Date: July 17, 1998
 Refer to: EM/ER:98-239

SUBJECT: RESPONSE TO REQUEST FOR SUPPLEMENTAL INFORMATION ON THE VCA REPORT FOR TAs-21 and -31 (FORMER OUs 1106 and 1079, FU 1)

**Response to Request for Supplemental Information
on Voluntary Corrective Action Report for
Potential Release Sites 21-013(c), 21-013(d), 21-013(e), and 31-001**

Figure 1. Cross section of east edge of regraded fill.

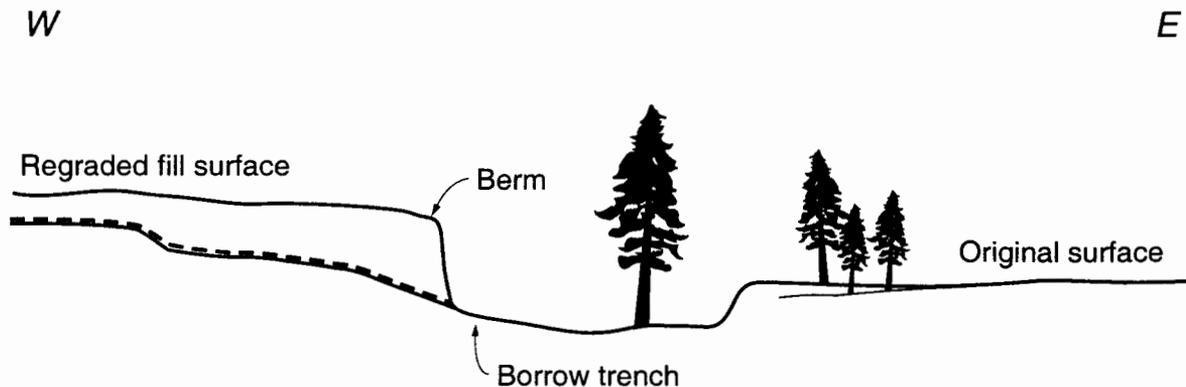
1. *Description, p.1. LANL should investigate the purpose of the excavated trench found on the site. Was it used for the disposal of liquid or solid wastes? Samples should have been taken from the bottom of the trench during the RFI and VCA sampling.*

1. The site feature referred to as an excavated trench in the VCA report has been researched further. Historical aerial photographs and site visits with a retired LANL employee who was involved in the early work at Technical Area (TA) 21 make it clear that the feature is a borrow trench at the edge of an area of regraded soil fill. This issue is addressed in the memorandum presented as Attachment 1. A cross section clarifying the feature is given in Figure 1. The west wall of the trench is 6 to 8 ft of fill. The bottom of the trench is exposed tuff bedrock with some thin soils (less than an inch) and sparse vegetation. At the east edge of the trench the terrain rises about 3 ft and is the original ground surface. The trench is about 100 ft long.

A review of historical photographs indicates the trench was constructed between 1946 and 1949. The photo record confirms that the trench has existed undisturbed since that time, with no evidence of waste disposal (Attachment 1). The surface debris piles that were defined as PRS 21-013(c) were associated with the soil fill to the west of the trench. Because there was no history of disposal in this area, and there were no debris piles in the trench, it was not included in the RFI investigation, the VCA debris removal activities, or the VCA confirmatory sampling. A copy of the set of aerial photographs is being made and could not be completed in time for the response submittal. The photographs will be provided when they are available (no later than August 15, 1998). Attachment 2 is reserved for the aerial photographs.

Figure 2. Excavation and confirmatory sampling locations for PRS 21-013(c).

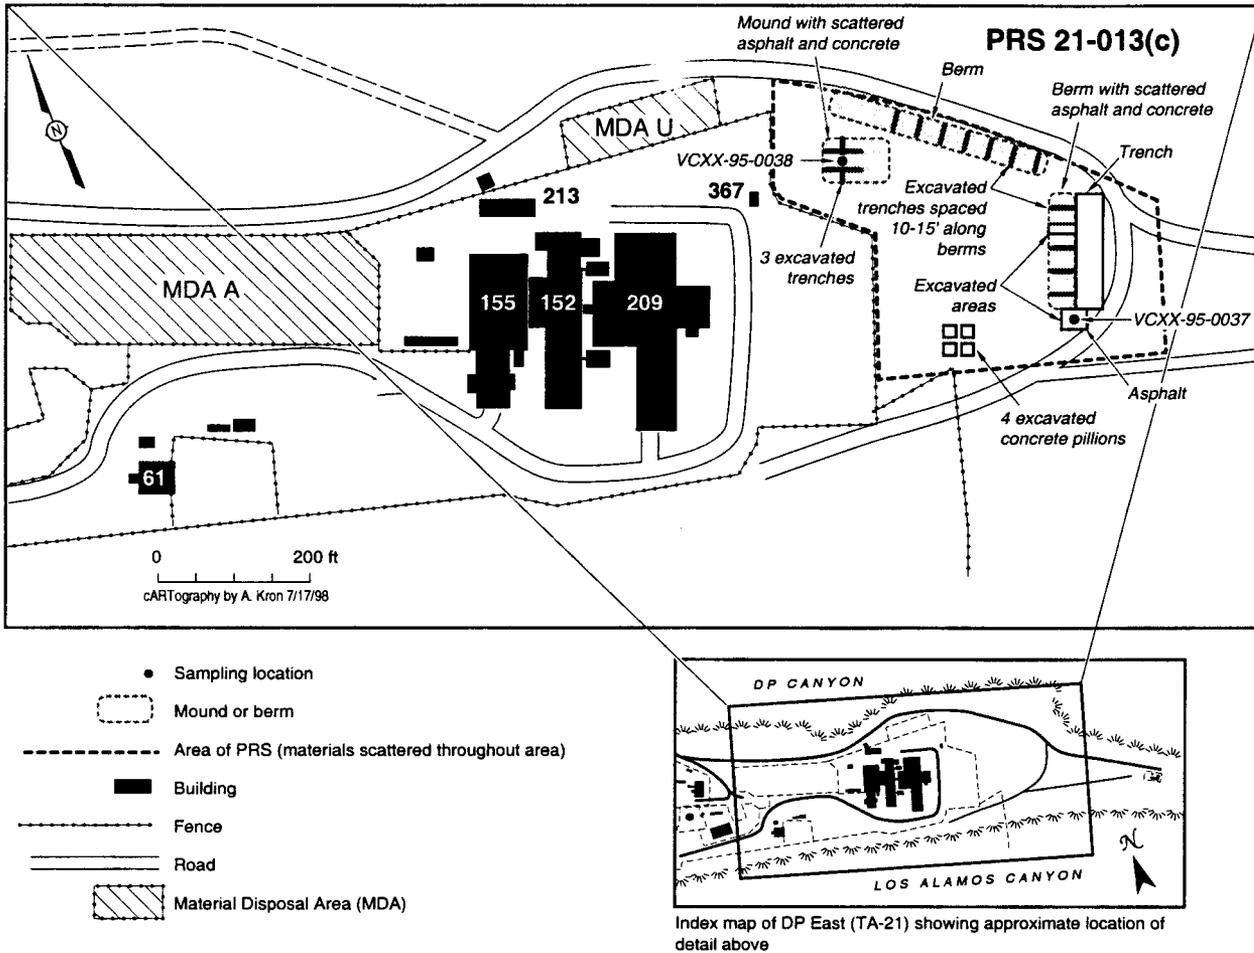
1. *LANL shall submit all the RFI, VCA and confirmatory sample data with associated quality assurance/quality control data for each PRS. Provide the site map with the location of debris/soil piles at the site. The sample locations, depths, backgrounds, SALs and detection limits should also be included in the data.*

To clarify the nature of the area of this PRS and the nature of the scattered debris addressed in the VCA, some before and after photographs are provided in Attachment 3. Figure 2, which shows the area, the parts of the area investigated, and the parts excavated, is reproduced here from the VCA report. The photographs give a sense of the nature of the scattered debris. It is re-emphasized that this was considered to be a housekeeping VCA, which was driven by construction debris and not by the presence of contaminants. Annexes 1 and 2 in this report contain the field and analytical data related to the RFI and VCA activities at PRS 21-013(c).

Figure 3. Excavation and confirmatory sampling locations of PRS 21-013(d), cold dump.

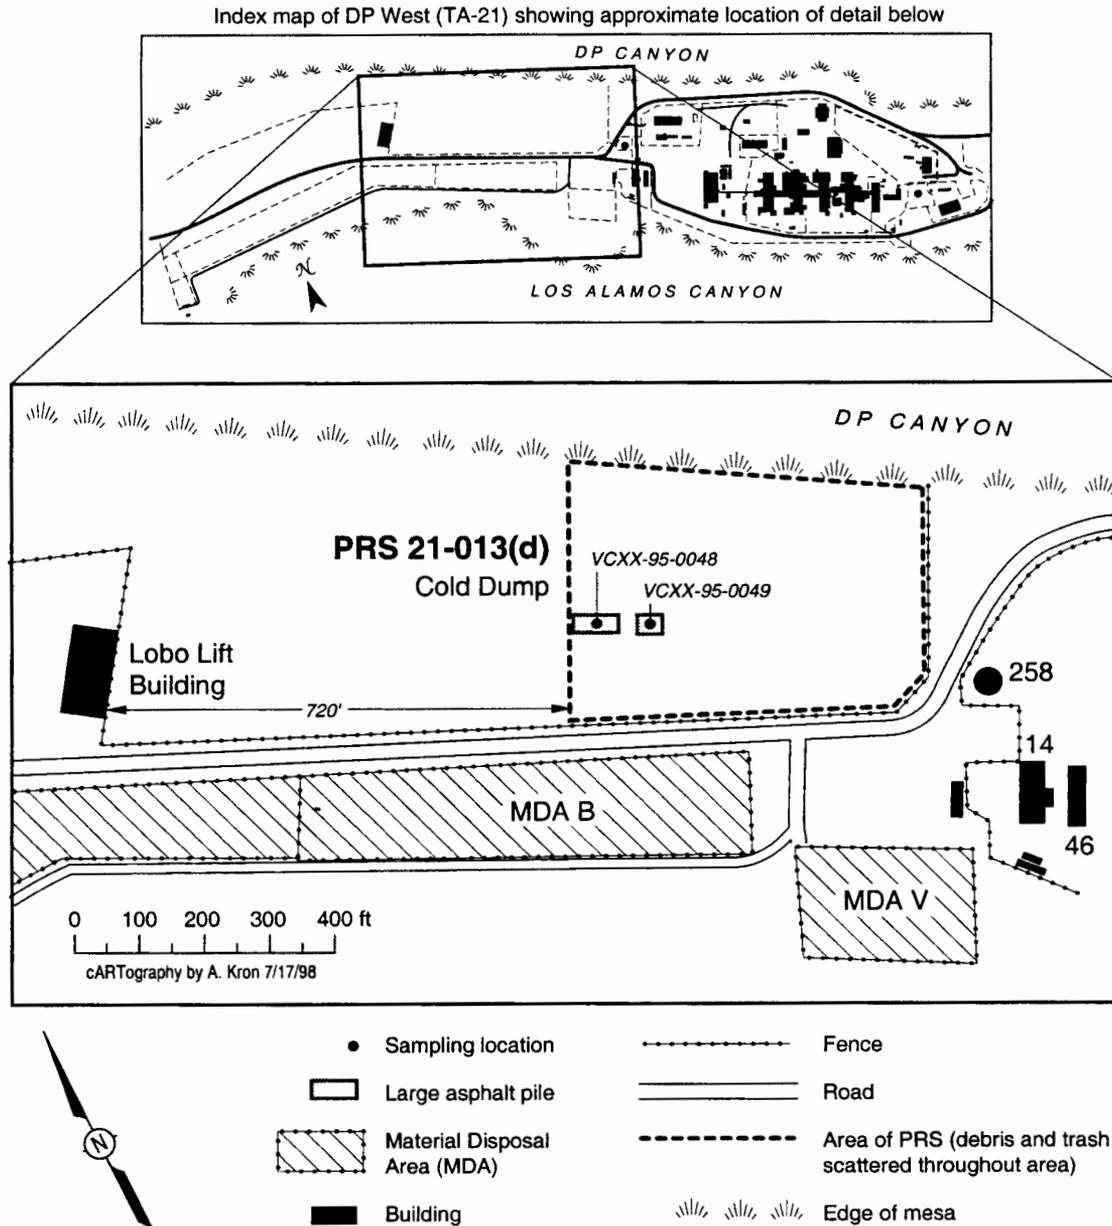
6. *RFI History, p.13. LANL states that "RFI data was collected prior to remediation, and did not include the areas beneath the waste piles (the focus of the VCA effort)." The areas underneath the waste piles should be investigated. Also provide a figure showing the location of waste piles at the site.*

6. Although the RFI characterization data did not address the areas beneath debris piles, the VCA confirmation samples were taken from areas that had been beneath debris piles. The results of these analyses were described in the VCA report (LANL 1996, 54320.1). Figure 3 identifies the areas where debris piles were excavated and where confirmation samples were taken. This same figure

appeared in the VCA report, with the exception that the dots indicating the locations for the confirmation sampling were corrected to show them falling inside the footprint of the removed debris piles. It is unclear why they had originally been shown outside the debris pile excavation areas, but it has been confirmed that they were within those areas. The number of asphalt-containing debris pile excavation areas shown on the figure is correct; only two were present and removed. The remaining materials collected for disposal were scattered individual pieces of debris.

Figure 4. Excavation and confirmatory sampling locations of PRS 21-013(e).

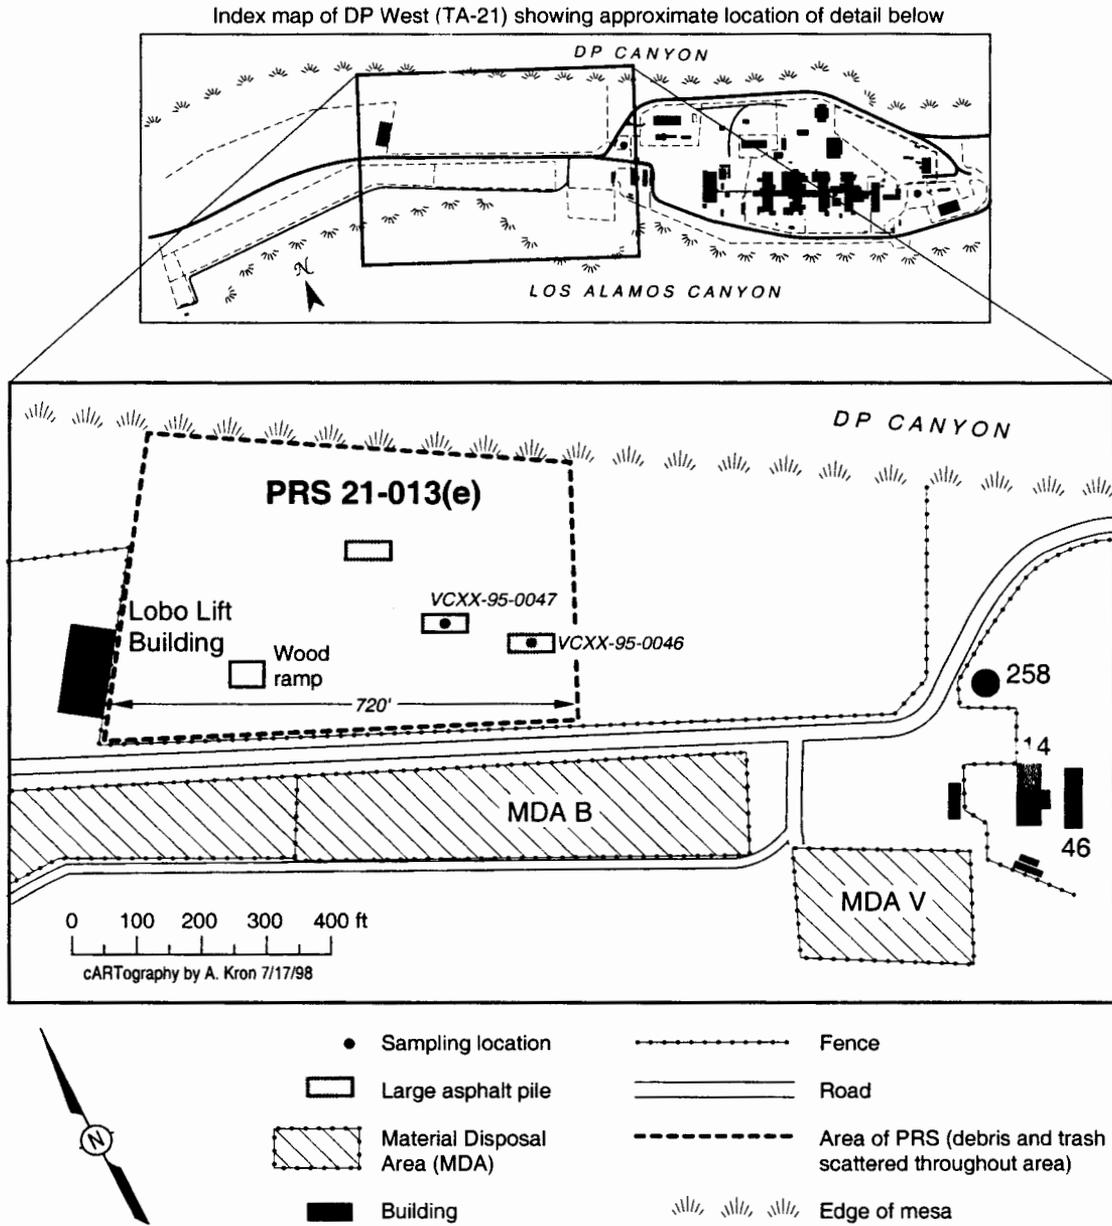
2. *RFI History, p.23. The report states that debris piles were scattered in the site. Were these piles sampled and included in the 18 grid sections investigated? The debris piles have the potential of containing contaminated waste and should be investigated. The area beneath the waste piles should also be investigated. Provide a site map with locations and outlines of debris piles.*

- The debris piles were not sampled individually as part of the RFI characterization but were contained within the 26 grid sections investigated. Of the 26 grid sections, 18 were sampled, as described in our response to Comment 3 on PRS 21-013(d). There were three discrete debris piles labeled as asphalt piles in Figure 4 and a wooden ramp in the area designated as PRS 21-013(e). The remaining debris picked up for disposal consisted of scattered individual items, such as pieces of concrete or asphalt pavement, lumber, cans, paper, and plastic trash. Figure 4 is the same figure that appeared in the VCA report, with the exception that the dots indicating the locations for the confirmation sampling were corrected to show them falling inside the footprint of the removed debris piles. It is unclear why they had originally been shown outside the debris pile excavation areas, but it has been confirmed that they were within the footprint of those areas. The number of debris pile excavation areas shown on the figure is correct; only three (plus the wooden ramp) were present and removed. The VCA confirmation samples were taken from the areas beneath debris piles.
